IN THE UNITED STATES PATENT AND TRADEMARK OFFICE

Ÿ		
Applicant:	Mark James Yunker)
Serial No.:	09/904,387) Group Art Unit: 3653
Filed:	07/12/2001) Examiner: Daniel K. Schlak
For: Slide	For Sorting Machine)
December 16, 2002		RECEIVED

RESPONSE TO OFFICE ACTION

FIG.3

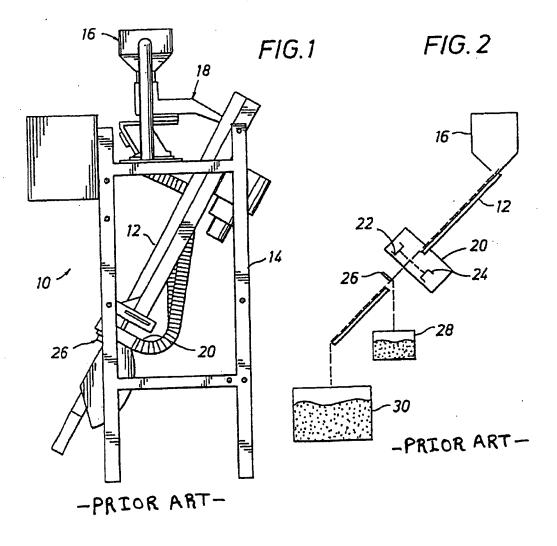
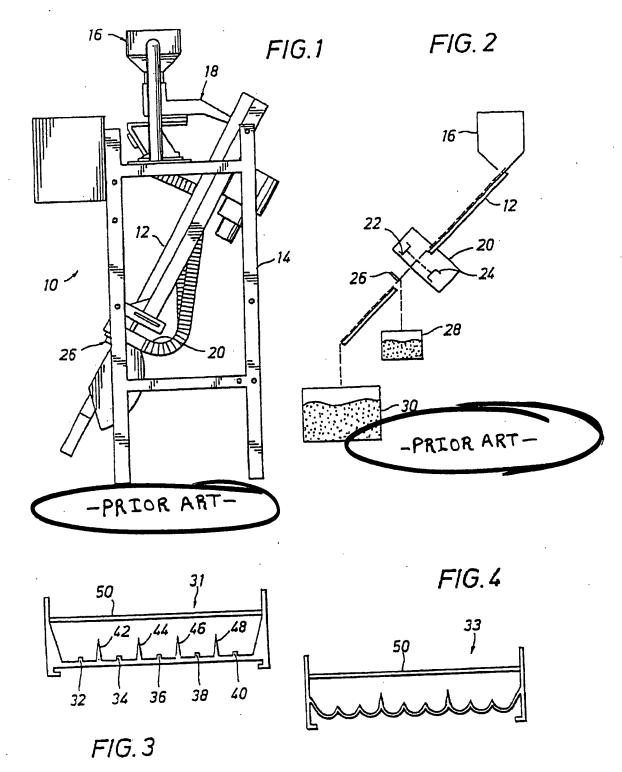
The applicant offers one (1) sheet of substitute drawings to include designations of -- Prior Art-- on Figs. 1 and 2. Figs. 3 and 4 each depict a representative product guide 50. Product guide 50 is an aspect of the present invention, so marking of Figs. 3 and 4 as Prior Art has been deferred pending action on this response.

The applicant offers substitute drawings for Figs. 1 and 2 to include designations of --Prior Art--. Figs. 3 and 4 each depict a representative product guide 50. Product guide 50 is an aspect of the present invention, so marking of Figs. 3 and 4 as Prior Art has been deferred pending action on this response.
